Model	Service Bulletin Description	Number
All	Water softeners O-rings Tygon tubing Back flow prevention Contactors SSM water filter parts Serial Number Format Change Ice machine sanitation after a boil order Color and Model Series Change	PS-6-88 PS-9-88 PS-2-89 PS-9-92 PS-1-98 PS-8-98 PS-8-2004 PS-7-2005 PS-6-2006
AC125	Water inlet valve New leg parts	PS-1-89 PS-7-97
AF300	New oil seal New water shed New motor and motor housing	PS-12-2002 PS-15-2003 PS-1-2005
AFE325	New oil seal New water shed New motor and motor housing New compressor	PS-12-2002 PS-15-2003 PS-1-2005 PS-5-2005
AFE400	Drain and water system parts Bin thermostat bracket change TXV change New oil seal New water shed New motor and motor housing New compressor Added hi pressure cut out	PS-11-97 PS-4-2000 PS-13-01 PS-12-2002 PS-15-2003 PS-1-2005 PS-5-2005 PS-1-2006
Bins	Door frames Gasket color change BH260 and BH375 parts BH360 bin SB480 bin BH1100, BH1300, BH1600 bin Ice Express Service Parts Ice Express Cart Service Parts BH801 Service Parts BH1100, 1300, 1600 changes	PS-2-2000 PS-4-2000 PS-14-2000 PS-8-2002 PS-4-2003 PS-6-2003 PS-2-2004 PS-3-2004 PS-10-2004 PS-5-2006

SERVICE BULLETIN

CHANGES TO CHUTE - ASSEMBLED

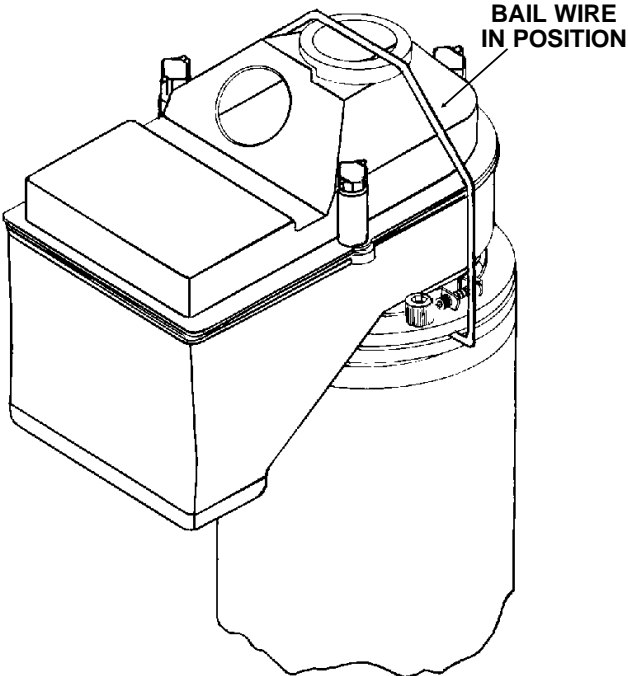
Beginning with January 1991 production, a clamp was added to the above models to help secure the ice chute assembly to the breaker. This required a change to the breaker; a groove was machined into the bottom of the breaker, and it is that groove that the clamp hooks into. This clamp is not retrofitable to prior ice machines. Service breakers at this time do not have the groove. The part number of the breaker and cover did not change.

The breaker cover has been changed from a stainless steel part that required a tool to remove, to a plastic part that can be removed by hand. Threads are still left-hand.

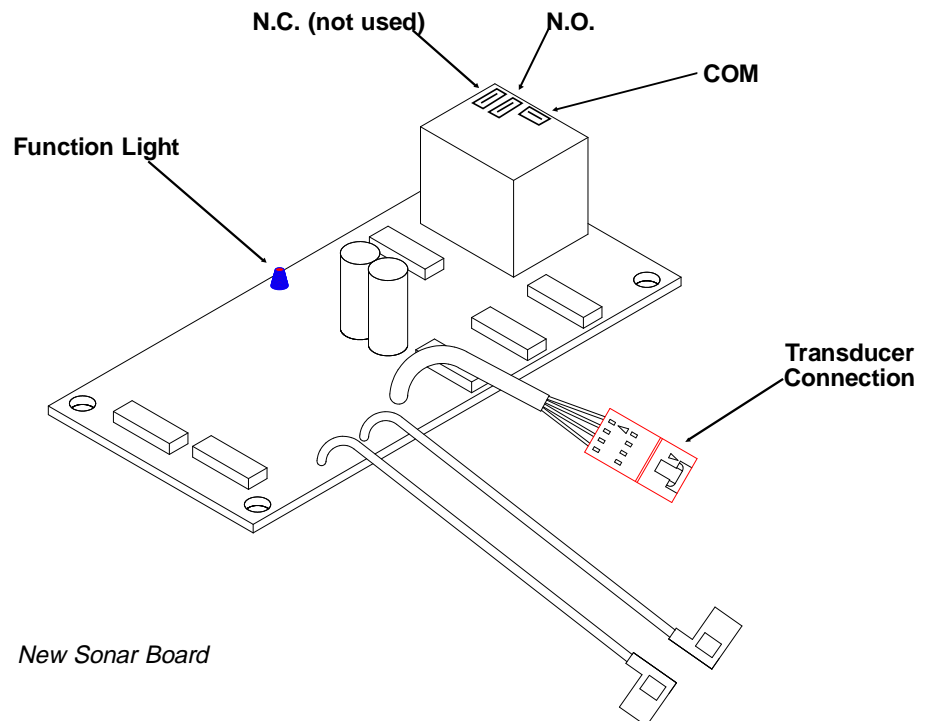
A change has been made to the sonar ice level control, beginning with with CMS and MCM machines manufactured after April, 1993 (date code -10L and higher).

The Sonar Board has had a function light added to indicate the status of the signal to the transducer and up to the relay on the sonar board. If this light is ON:

The transducer has also been changed. An additional circuit has been added, connecting low voltage power to an internal resistor (a small heater). The new sonar board has a connection for the new transducer. An adapter cord is required to use the new transducer with the older boards, and is included with the transducer kit described below.

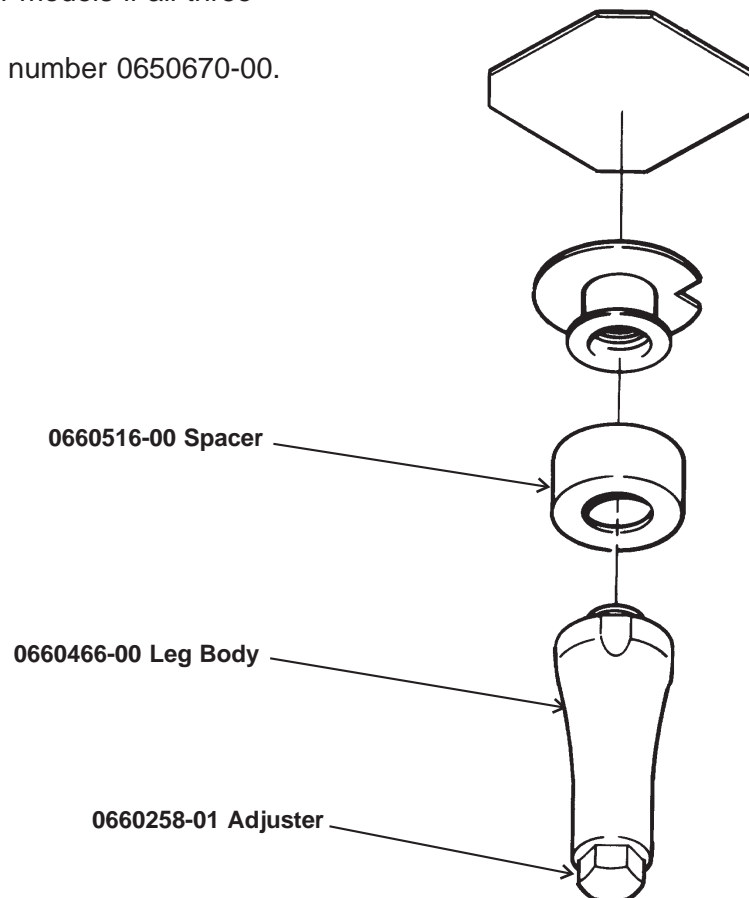
The design of the legs for these models has changed. CS60s now ship with these legs. These new legs fit the prior models if all three parts are used.

A set of 4 complete is part number 0650670-00.

Prior Layout
Wires are bundled together

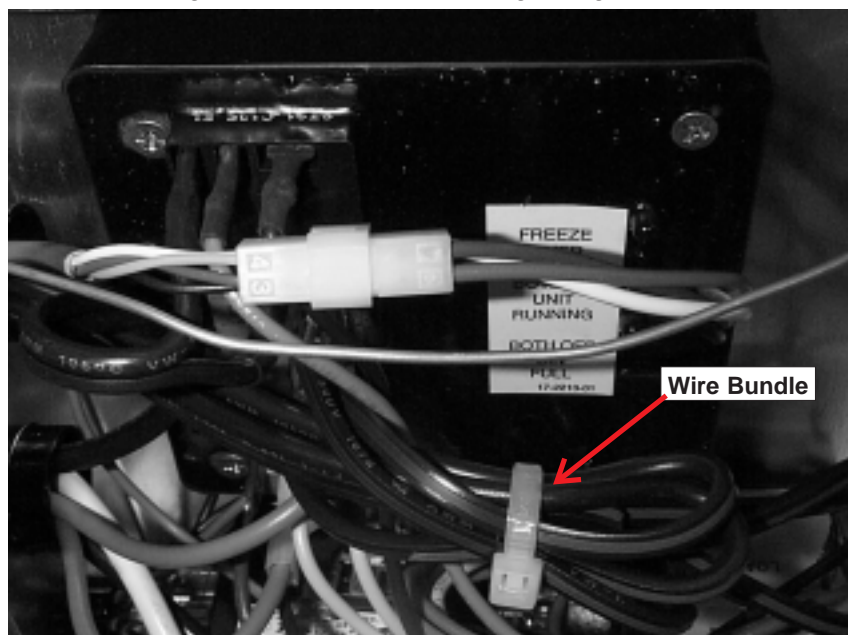
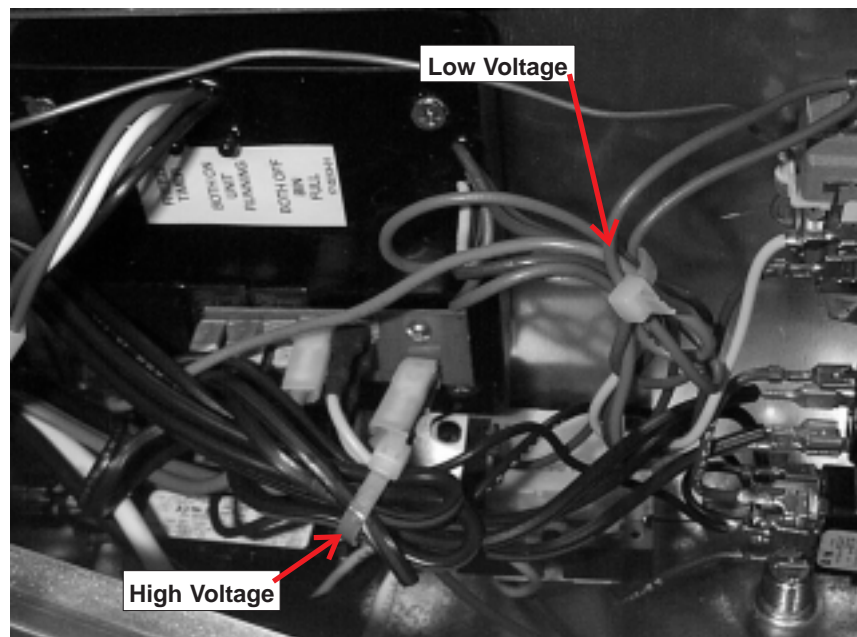
The control module in the SCE170 has been **rotated** to improve wiring layout. Production of machines with the module rotated began with **July 1998** production. The first serial number is: 120714-12B. Additionally, the curtain's bottom edge has been cut back beginning with sn: 120790-12B.

New Layout
Module is rotated and wires are separated into high and low voltage bundles.
This can be done in the field by cutting the cable ties, removing the four module mounting screws and rotating the module 90° counter-clockwise. Then remounted with the original screws. The wires should then be bundled as shown.

Subject: Insulation Change

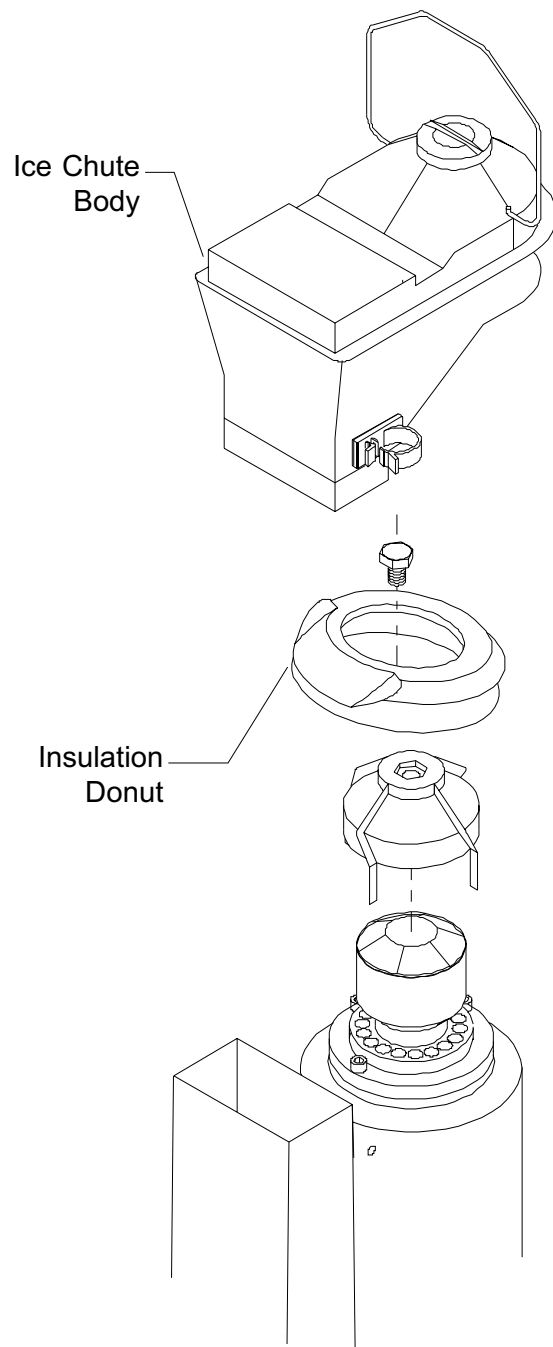
An insulation collar has been added to the space between the lower chute and the top of the evaporator. There is one collar (it looks like a big donut) for FME models and a different one for the nugget machines. The donut replaces the styrofoam insulation inside collar (pn A33102-001)

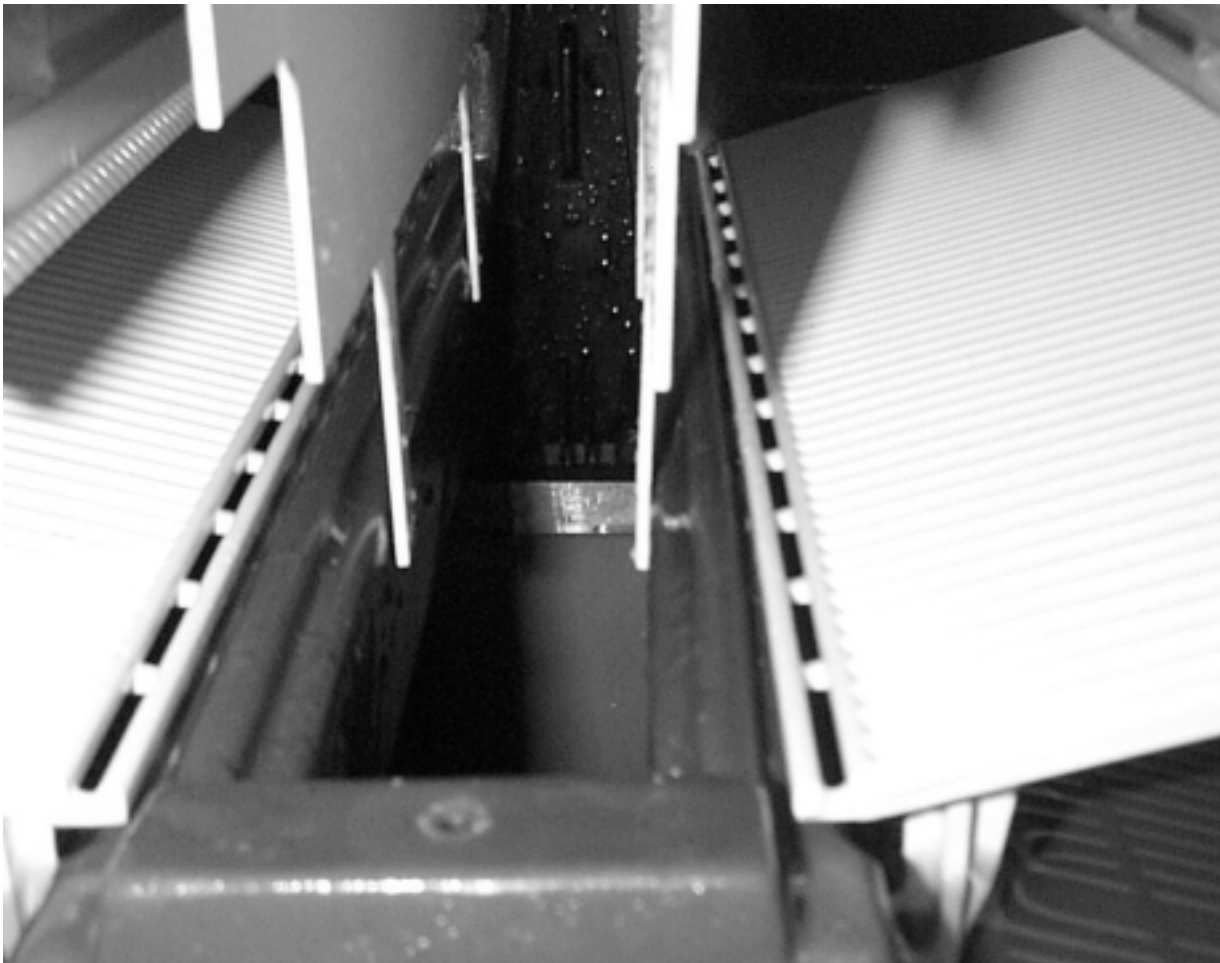
This kit includes the gaskets, brackets, shields, hardware and the controller harness required to stack any combination of these three models. The new kit is simpler, easier to install and more tolerant of installation variables. The prior system included an upper unit drain that is no longer used.

One key difference is the shields used to guide the ice through the lower unit. The shields for the new kit hang from hooks and are aligned by gravity. They also have tabs to limit their outward movement. The tabs insert into the ice outlet port of the bottom unit, as shown below.

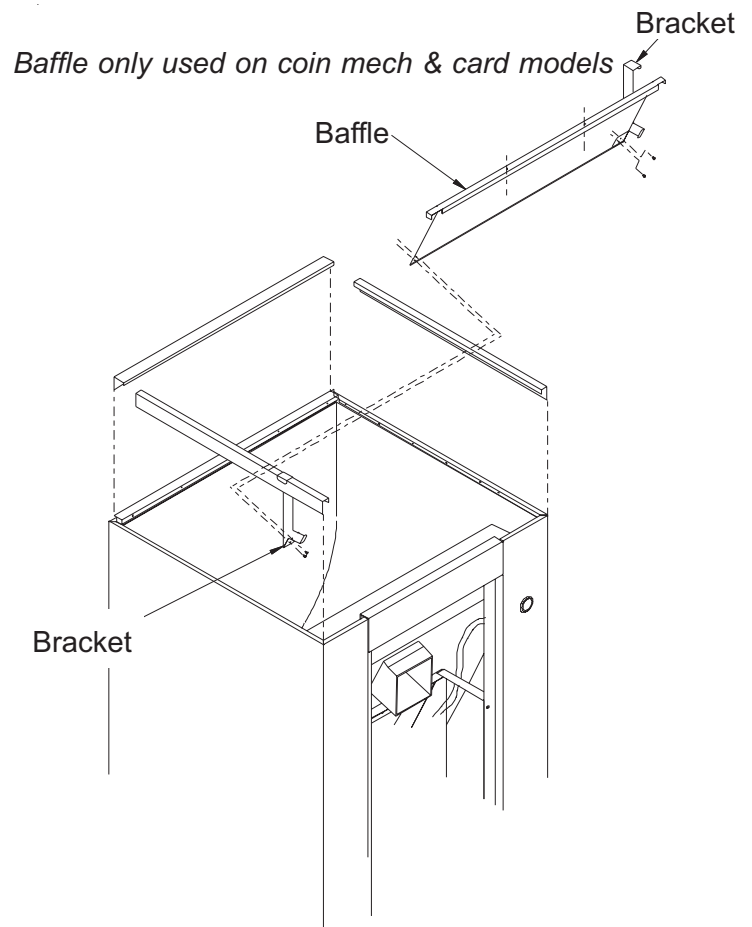
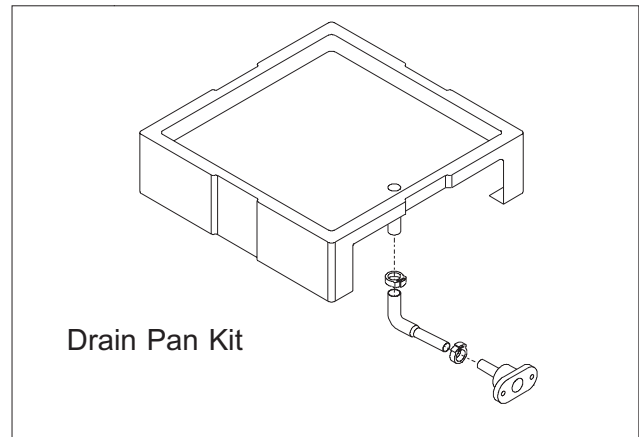
The size of the drain line from the drain pan to the cabinet drain of the HD356 has been enlarged for improved draining.

This change required a change to the drain pan. The drain pan kit part number is **A38021-001**, replacing A34694-001. The kit includes a pan, new tubing and a new adapter. All HD356s built after date code -02R have this change.

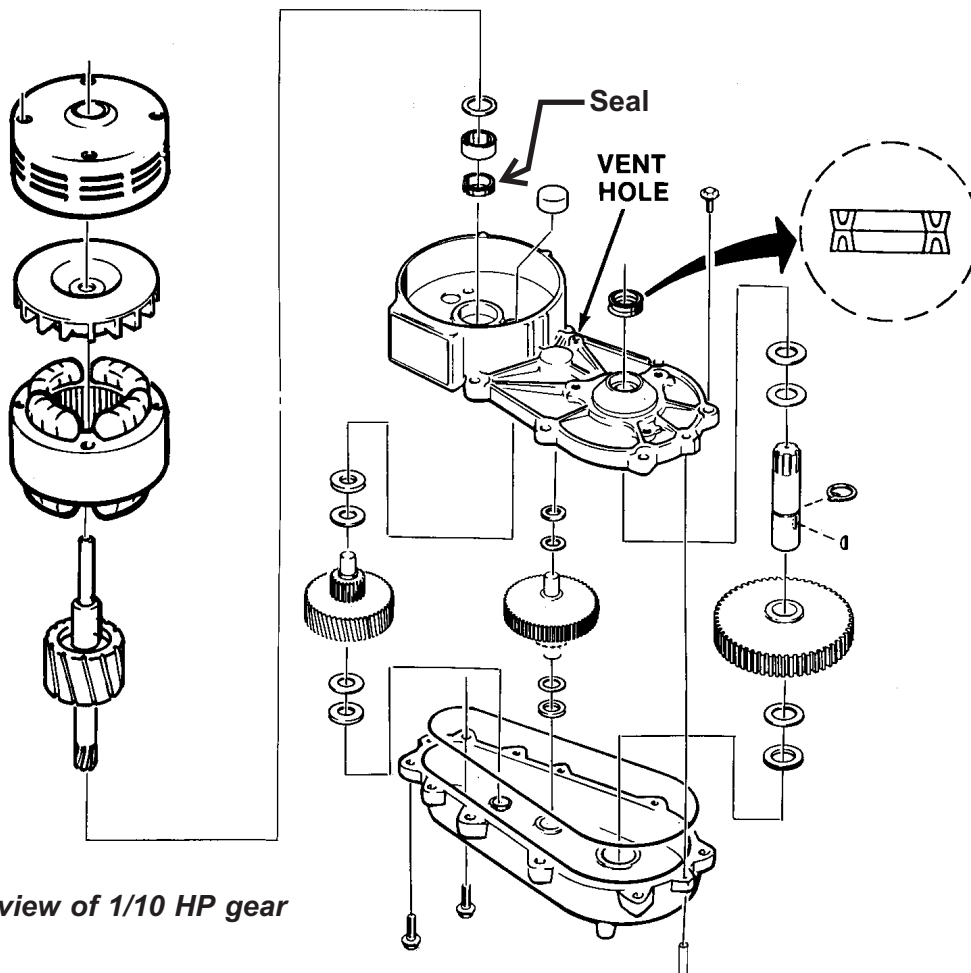
The input shaft oil seal has been changed **from two** 02-1504-00 seals back to back to **one 02-3969-20** seal.

When replacing the input shaft seals, remove BOTH input seals and install the new seal with the U-Cup facing the oil.

Subject: CSW45 evaporator and thermistor change to C series

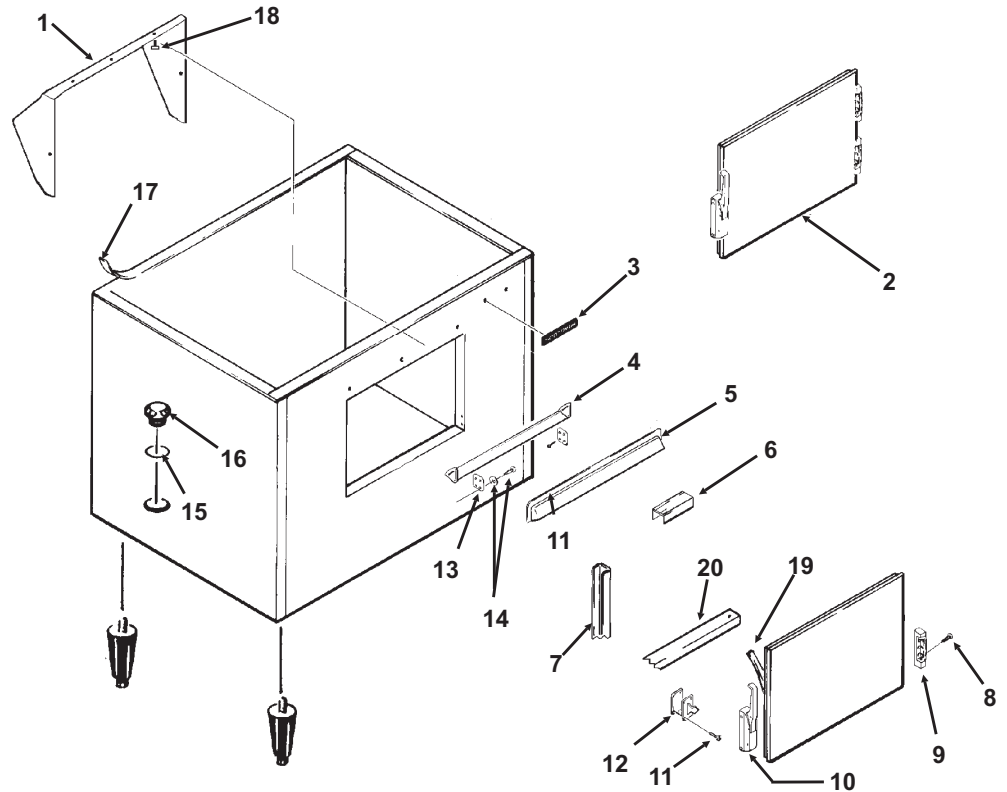
The evaporator in the CSW45 has been changed. Beginning with C series units, (CSW45-1C), the suction line diameter has increased. This required a change to the thermistor that mounts to the suction line.

Replacement evaporators will now come as a kit with the matching thermistor so they will fit any CSW45.

Replacement thermistors will now come as a kit with both large and small thermistors so they will fit any CSW45.
